Addendum No. 03

File Reference Number: RFP 2025 093

Title: Engineering Services for Truck Shop Expansion

RE: Clarifications/Questions

5- Scope of Work Review

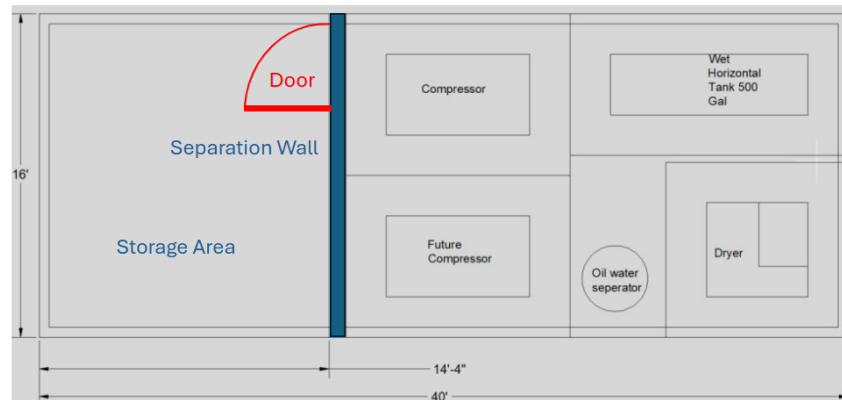
Item 21: Appendix F & Appendix G: Could you please provide Appendix F and Appendix G referenced under “Compressed Air and Associated Items”?

Answer: Provided. See further information involving the compressor and electrical equipment being installed in a Sea Can. Engineering will happen in December/January, and construction will commence in February/March.

Sea Can Equipment Arrangement:

- 500 CFM Air Compressor
- 1000 CFM Air Dryer (Cycling Desiccant Dryer)
- 500 – 600-Gal Horizontal Air Receiver (Wet Tank)
- Oil Water Separator
- HVAC System.
- Electrical Panels

Indoor Equipment:

- 1000-Gal Vertical Air Receiver (Dry Tank)
- Control Panel
- Electrical Panels
